## iCtp PW INFUSE Service tool update

Valid for following product(s):

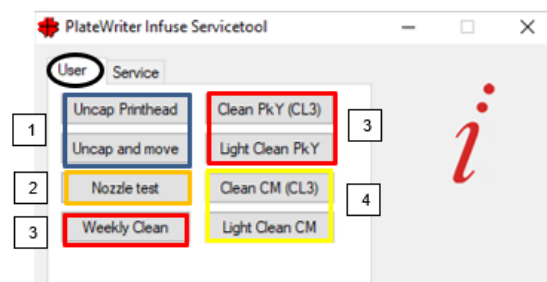
There was a bug in the GJ service tool which occasionally triggered the 150C error during the un-cap move sequence.

A new version of the Service Tool is now available.

The error has been corrected with a build in delay, so the Pump-Cap-Assy will be unlocked before it moves the carriage from home position and finally power off.
